SAN FRANCISCO PLANNING DEPARTMENT

DATE:	May 28, 2014
TO:	Architectural Review Committee of the Historic Preservation Commission
FROM:	Allison Vanderslice, Preservation Planner, (415) 575-9075
REVIEWED BY:	Tim Frye, Preservation Coordinator, (415) 575-6822
RE:	Review and Comment at June 4, 2014 Hearing LightRail Installation - Path of Gold Light Standards along Market Street from The Embarcadero to Van Ness Avenue Case No. 2014.0794A

Technical Plans

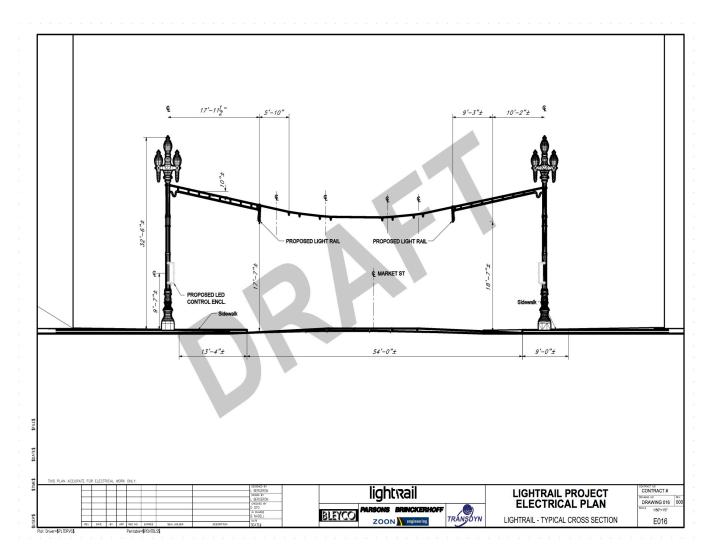
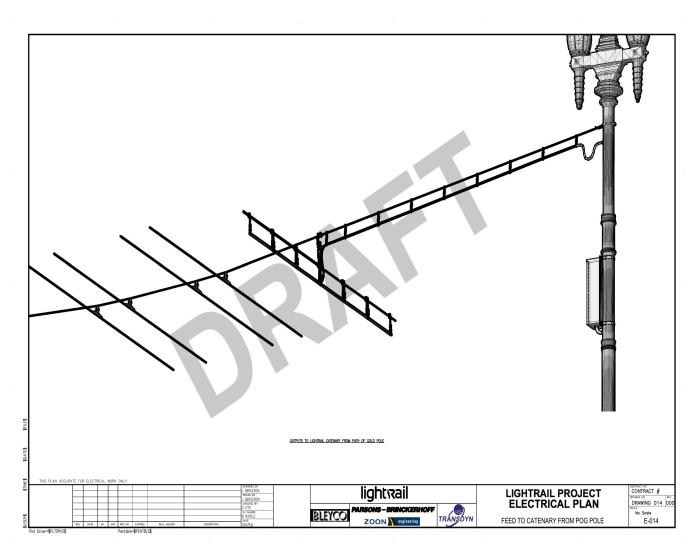
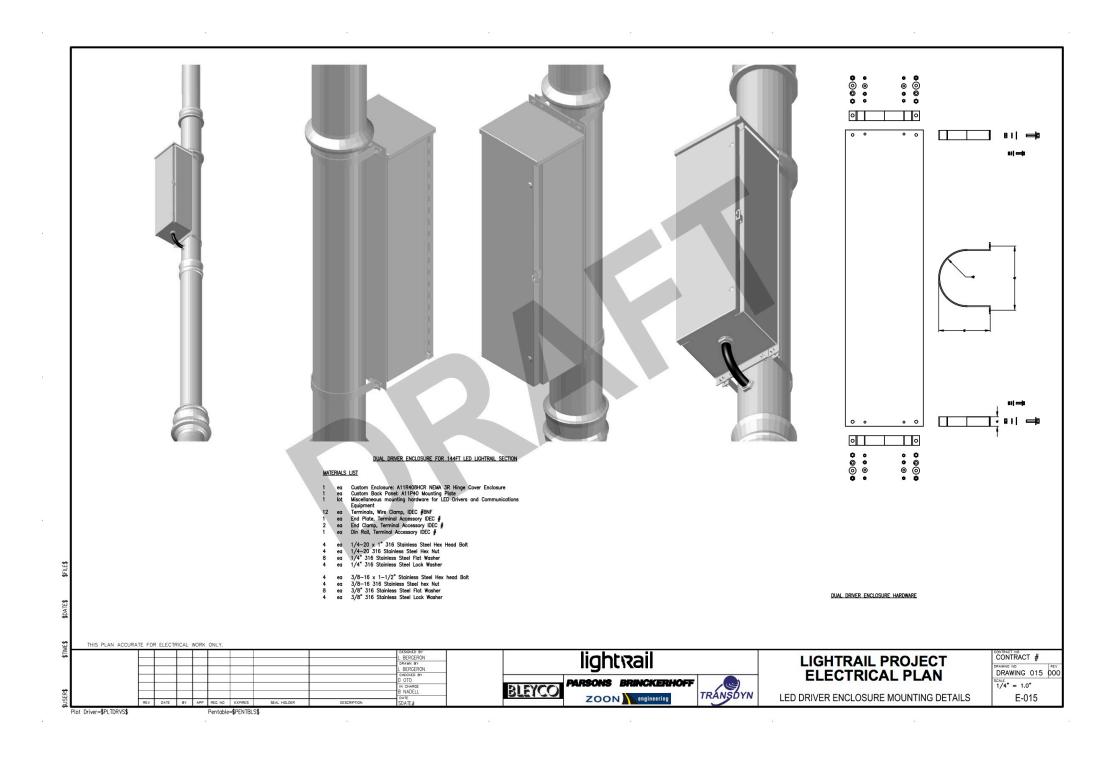
The Department finds the utility box location and design unresolved and in conflict with the Secretary of the Interior's Standards. While the proposed utility boxes are simple metal boxes with a utilitarian design, the Department finds they are not compatible with the stylized POG standards. In addition, the overall number of utility boxes installed on the exterior of the POG standards (83) will result in a cumulative visual change to a significant portion of the POG from the Embarcadero to Van Ness Avenue.

- 1. While the design of the utility box aims to recede from view, the utilitarian and strictly rectangular design is visually jarring in contrast with the ornate lamp poles. Staff recommends that the LED driver be housed inside the hollow POG pole or base, reducing the need for an external box.
- 2. If there are no reasonable means to house the LED driver within the hollow POG pole or base, staff recommends that the sponsor provide a more integrated and compatibly designed utility box. The Sponsor might consider shaping or beveling the edges and corners of the box, or using other methods to significantly reduce its profile. The Sponsor may also propose a design that integrates more specifically with the POG and the theme of the LightRail installation.

The Sponsor proposes to use metal clamps to attach the utility boxes around the POG poles. In the past there have been issues related to deterioration and corrosion through the use of metal fasteners on the POG. Unless properly installed, the metal fasteners may lead to water collection and eventual damage and corrosion to the POG poles and its finish. Further design work is necessary to ensure that the attachments and the box itself will not damage the pole and will not result in further deterioration.

3. The Department recommends the Sponsor specify protective measures, such as the installation of a protective material, in order to protect the POG from potential damage and/or corrosion caused by the clamp and utility box.

As proposed with the installation of the 11.5" wide, 40" high, and 8" deep external utility boxes, the project proposes to drill a ³/₄" hole in the POG pole to run wires to connect to the utility boxes. The Department understands that hole will be filled in and repaired at the end of the installation. The Department further understands that the installation is designed to be reversible and to cause limited alterations to the POG.

- 5. The Department recommends that Sponsor prepare a repair detail for filling and repairing the ³/₄" hole drilled in the historic pole.
- 6. The Department also recommends that the Sponsor's plan anticipate additional repair and restoration, including repainting of the POG, following the removal of the LightRail installation.
